Title: **Technical Document, Drain Tank Information for Developing Design Basis of the Preliminary Design**

WBS No. (L-4): 1.2.1		Required by Date: 7/13/11	
US ITER Document Number (when applicable): US ITER 12106-TD0003-R02		Routing for Approval Start Date: 7/7/11	
Author ¹ : Juan Ferrada		Author Sign/Date: <i>[Signature]</i> 7/8/11	
v	Role ²	Sign/Date	Notes/Comments, if any
	Technical Editor	Cindy Lundy	
✓	Administrative Assistant (Formatting/proofing) Highlight or Circle one:	Tonia McPeters Dina Clark Sherry Rowley Cerissa Gifford Pat Smith	<i>SRowley 7/7/11</i>
✓	WBS Team Leader	Jan Berry	<i>JBerry 7/7/11</i> SR
	Computer IIS Manager	Dan Ciarlette	
	Communications & HR Mgr	Bonnie Hébert	
	Procurement Manager	Jeff Geouque	
✓	Chief Engineer	Brad Nelson	<i>BNelson 7/24/11</i>
	Business Office Manager	Jama Hill	
	Project Controls Manager	Wayne Steffey	
✓	Quality & ES&H Manager	Frank Casella	<i>FCasella 7/21/11</i>
	Building Coordinator	Loretta Simpson	
	CS Systems Manager	Chris Rey	
	Magnets Sys Chief Engineer	Nicolai Martovetsky

DRAIN TANK INFORMATION FOR DEVELOPING DESIGN BASIS OF THE PRELIMINARY DESIGN

Revision	Date	Description of Changes
00	1/7/2011	Original
01	3/23/2011	Com

Fig. 11. Direction of drain tank installation.

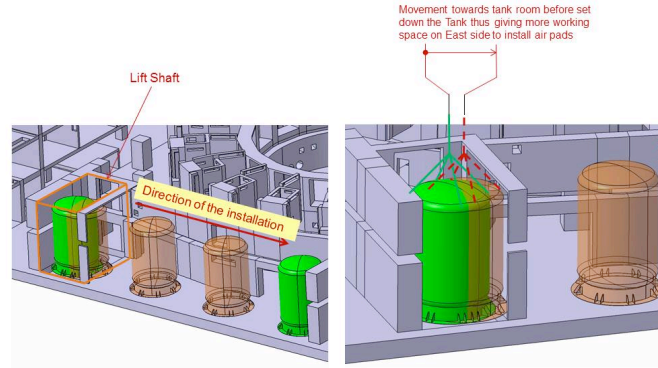
13	NBI connection to drying system—mistake on slide?	US ITER to review Figure 11 for services to tanks.		This will be fixed in the document by US ITER.
14	Minimum design metal temperature.	US ITER (Juan) to provide.		At B2 level (–11.6 m below the ground level), the minimum design temperature has been established at 12°C. US ITER will provide a list of environmental variables and their values at the same time this spreadsheet is delivered.
15	Electrical grounding for drain tanks.	How many grounding lugs will be required for each tank.	IO question.	It is not established yet. We need to uniform this according to the indications from the electrical section. I presume that could be at least two. However, there will be a workshop on TCWS I&C during October where this question will be definitively answered.
